2405/Mag/WCBC/Queries/mjs

Adrien Young  
Magellan Aerospace  
Rackery Lane  
Wrexham LL12 0PB

## **RE: GAS MONITORING RISK ASSESSMENT- MAGELLAN**

*Figure 3f from GSL Geo-environmental Report.*

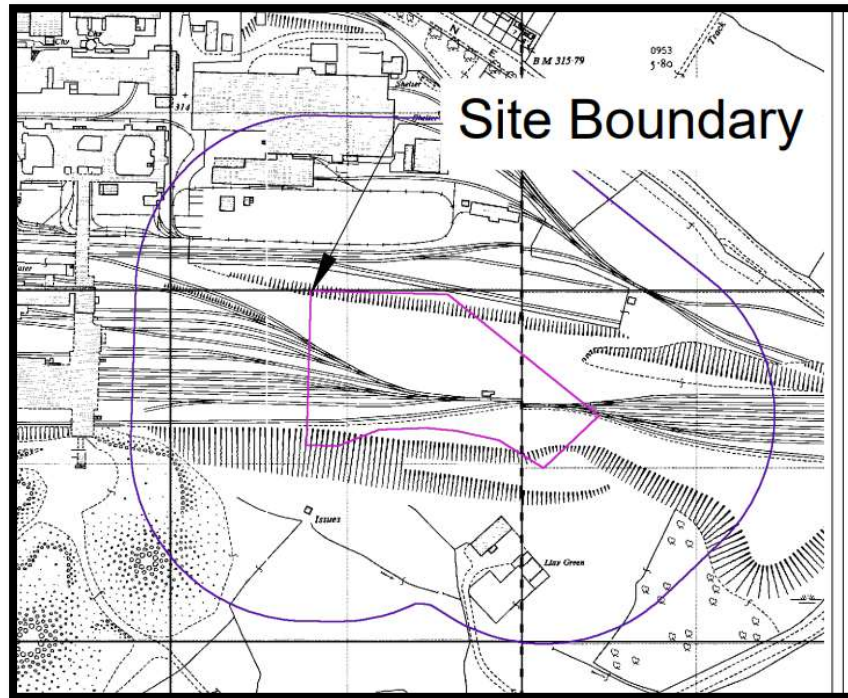
Following issue of eh GSL geo-environmental report for the above scheme in November 2020. The client received a memo from Angela Guy of Wrexham County Borough Council (WCBC) stating that further information is required regarding contamination and landfill gas risks to discharge the planning conditions, with particular regard to the:

- Former sidings,
- Ground gas, as made ground has been identified at the site up to 4.70m thick.

The overhead gantry to the west of the site would have been used for loading the coal wagons through hoppers. As can be seen from the OS plan presented below there were numerous hoppers for loading the wagons. The trains and wagons then need to be turned around, hence the configuration of tracks observed, with a dead end to the east of the site. It should also be noted that very few lines were present on site, and their configuration confirms that trains would not have been stockpiled so close to the pinch point.

Therefore, the risk of potential contamination from the railway lines is considered to be very low.

This was confirmed by the chemical testing, where for a 'Commercial' end, using the most conservative SOM content of 1%, no exceedances of any potential contaminants were recorded. This being the most appropriate end use for the development, as the site is being entirely covered by an industrial building and associated hardstandings. Therefore, this eliminates the human health risk to future land users, as any potential pathways had been broken.
